# REPLACEMENT SYSTEM VARIANCE REQUEST

**SUBSURFACE WASTEWATER DISPOSAL SYSTEM APPLICATION**

Re: Burns Road  
Map #5, Lot #203  
Septic System

Subject: Division on-site evaluation of recently installed and now failing waste water disposal system, Maurice Dubard property, Burns Road, Augusta

**DISPOSAL AREA CROSS SECTION**

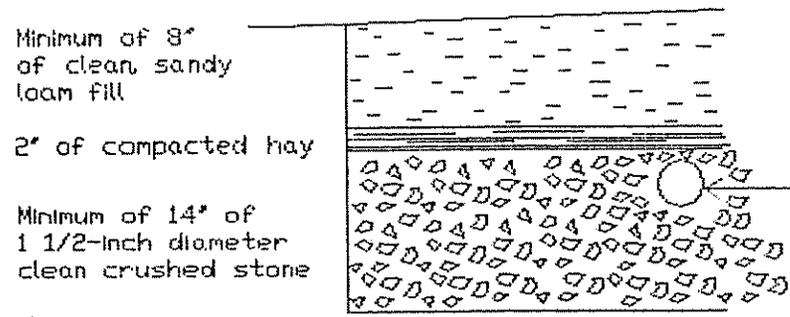
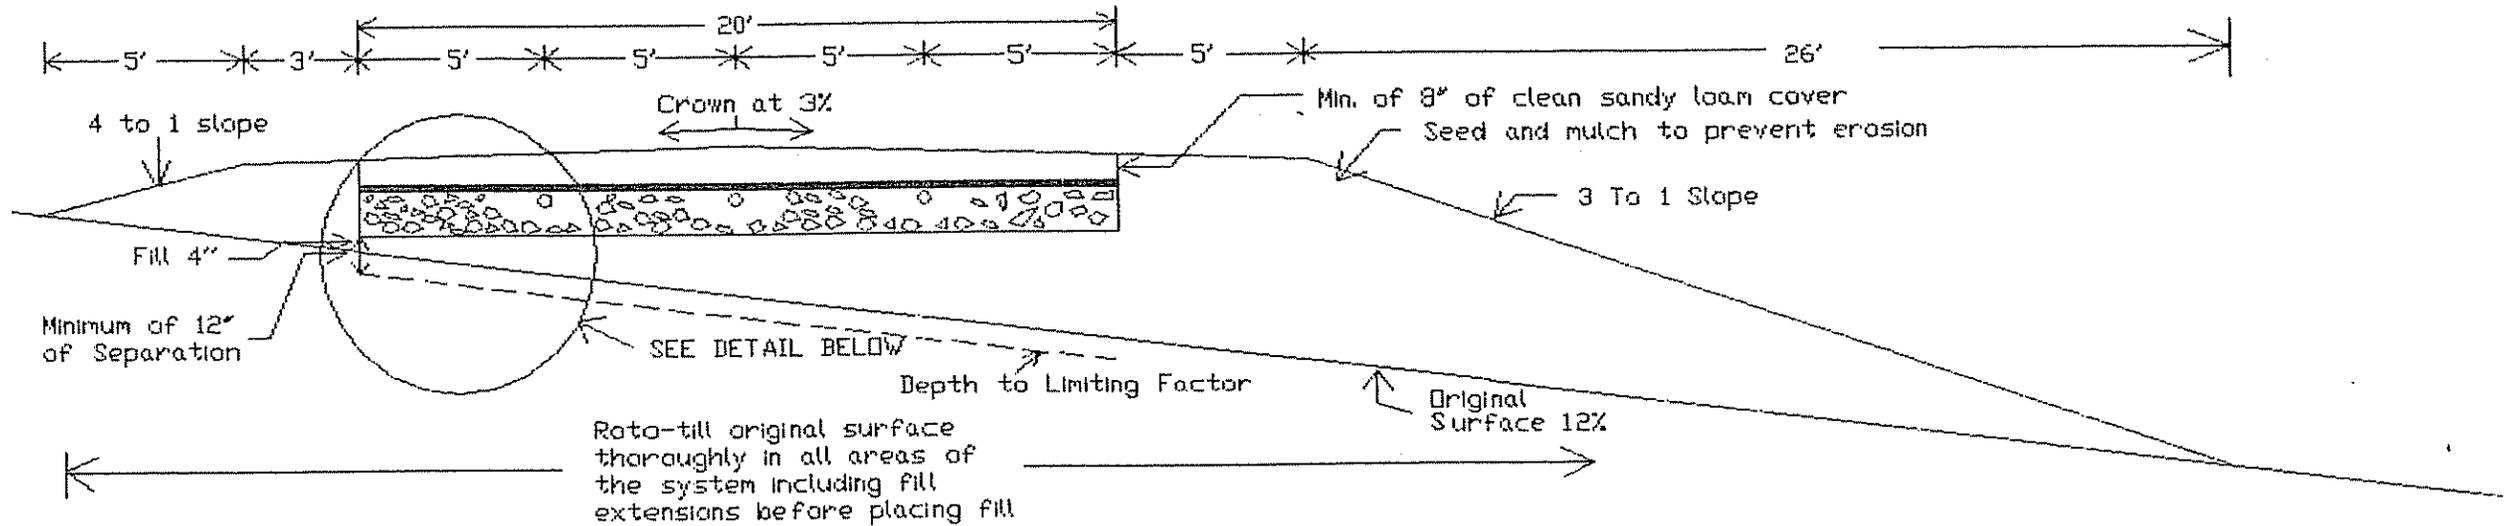
\* The improper preparation of the bed disposal area site, i.e. the disposal area location designated by Eugene Dube, SE in his design does not appear to have been adequately prepared by the system's contractor. Note: see the site evaluator's *DISPOSAL AREA CONSTRUCTION NOTES* found on page 3 of 3 of his design (enclosed) for specific construction details. These construction requirements were (and are) very important to the proper long term functioning of the system.

- 1 Rototill disposal area and fill extensions.
- 2 place 8 inches of coarse loamy sand fill on the disposal area and fill extensions and rototill into soil.
- 3 Place remainder of fill and construct disposal area in accordance with Maine subsurface wastewater disposal rules.
